FEDERAL TRANSIT ADMINISTRATION

CLIN 0005: Spot Report
Spot Report #1: Cost Validation Report

Honolulu High-Capacity Transit Corridor

Cost Validation Report
May 2007

Exhibit III-1
Variance Analysis: By Cost Category
Honolulu "New Starts Project"
(Fully Allocated Contingencies)

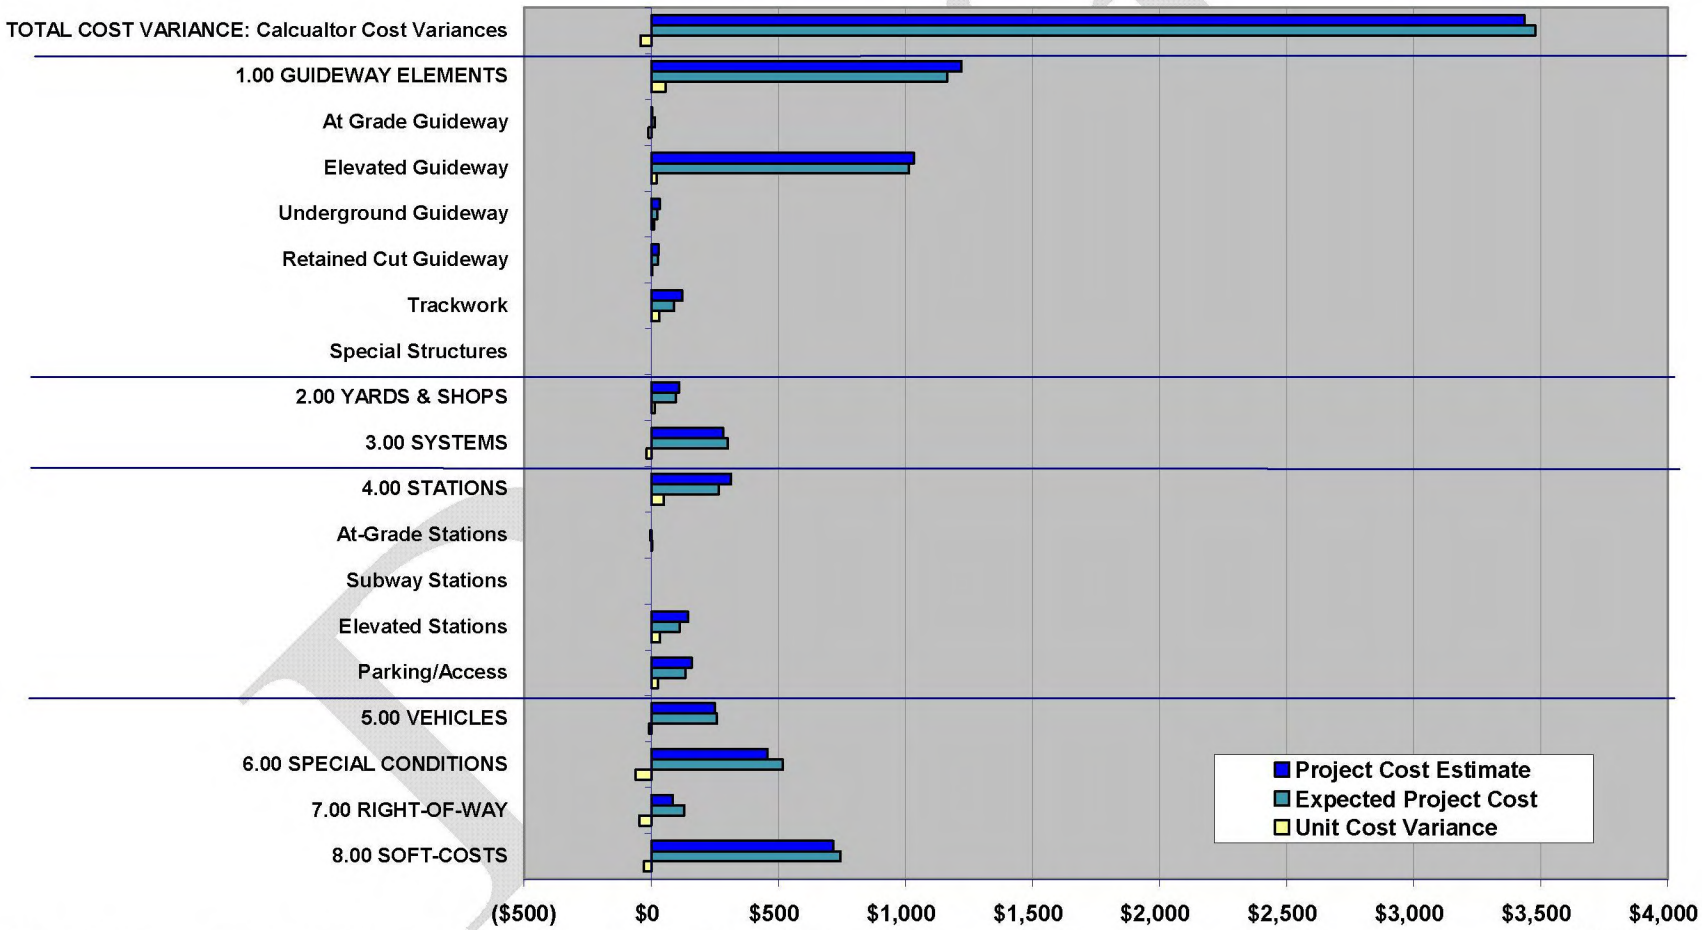
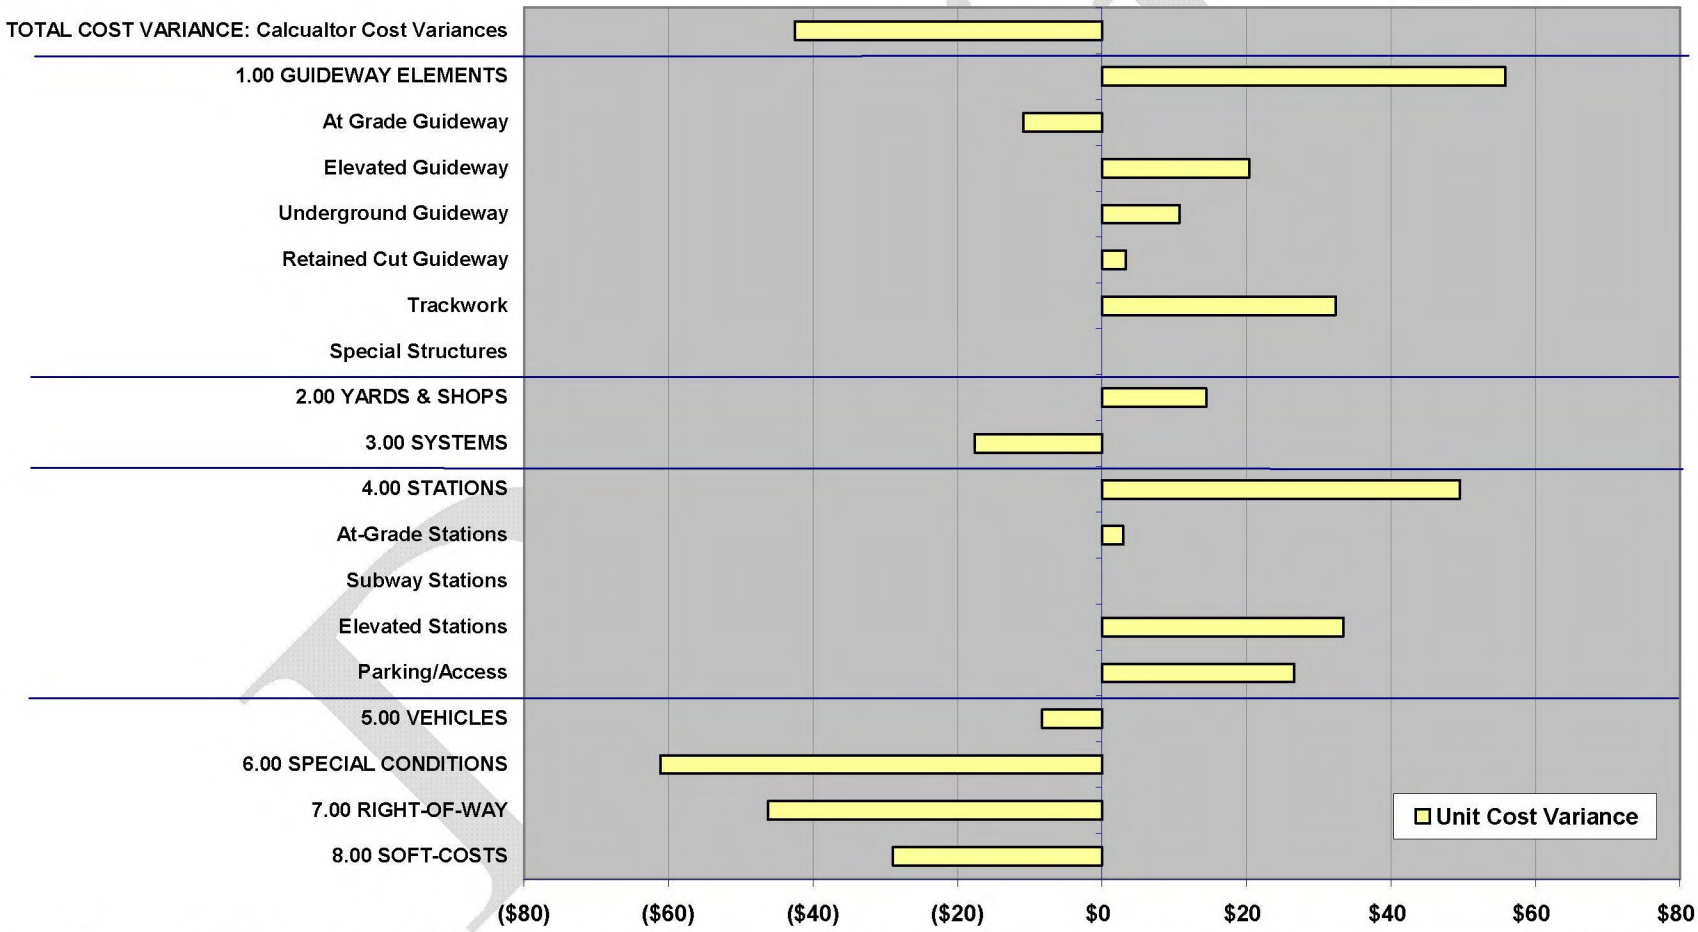
The results of the top-down cost validation analysis are presented graphically in Exhibits III-1 and III-2 (above) and as a table in Exhibit III-3 (below). For the project as a whole, as well as for each cost category and several major category elements, Exhibit III-1 presents:

In contrast, Exhibit III-2 presents only the cost variances, which helps focus attention on those cost categories with the greatest cost variances. Exhibit III-3 presents the cost values behind all of these results in tabular form. Following are analyses of the results presented in these exhibits, beginning with a discussion of the individual cost categories then followed by an assessment of the total project cost:

Total Project Cost: The top-down analysis suggests that the current project cost estimate for the New Starts definition of the High-Capacity Transit Corridor is roughly $42 million, or roughly 1.2%, lower than the project's expected cost based on the sample of projects recorded in FTA's Capital Cost Databases. As discussed further below, the negative cost variances for special conditions (including utility relocations, roadway changes, demolitions and environmental mitigation), right-of-way acquisition, and soft-costs are the prime drivers of the slightly less than expected project cost (based on prior cost experience). In contrast, the current project cost estimates exceed the database predicted values for guideway elements (track and structure), yards & shops, and stations.

Therefore, the fact that special conditions, ROW, and soft-costs account for much of the negative cost variation in Exhibits III-1 through III-3 (i.e., between the project cost estimates and the historical database values) is not unusual, but still grounds for further investigation. As discussed further below (under project risk), follow-on analysis has identified additional reasons for suspecting that the cost estimates for these cost categories may be underestimated and the Honolulu High-Capacity Transit Corridor Project team may want to revisit these cost estimates (in particular those for special conditions and right-of-way acquisition) as they move towards PE.

Exhibit III-4

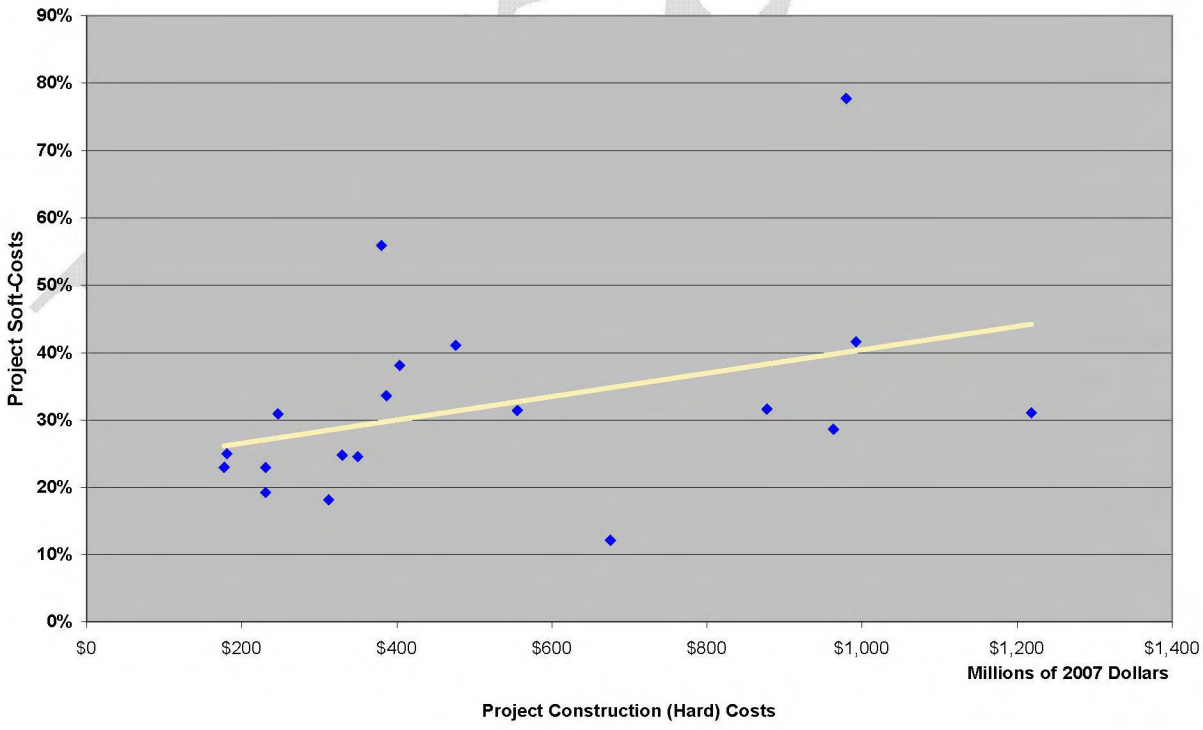
8.0 Soft-Costs: Project soft-costs include the cost of PE, final design, construction management, project management and oversight, finance charges, and training, testing and start-up. The project cost estimates of $715.7 million for soft-costs were found to be close to $30 million, or roughly 4%, lower than expected based on the sample of projects in the FTA cost database. Project staff justified this lower cost on the basis that projects whose costs are dominated by high expense items such as long aerial or subway alignment investments tend to have lower soft-cost expenditures (when expressed as a percent of hard costs). However, if anything, the relationship between soft costs and other project costs is a positive one based on analysis of the rail projects documented in the FTA Light and Heavy Capital Cost databases. In other words, not only do *total* soft-costs increase as project construction costs increase, but soft costs also account for an increasing (not decreasing) share of total project costs as project construction costs increase. This relationship is presented below in Exhibit III-4.
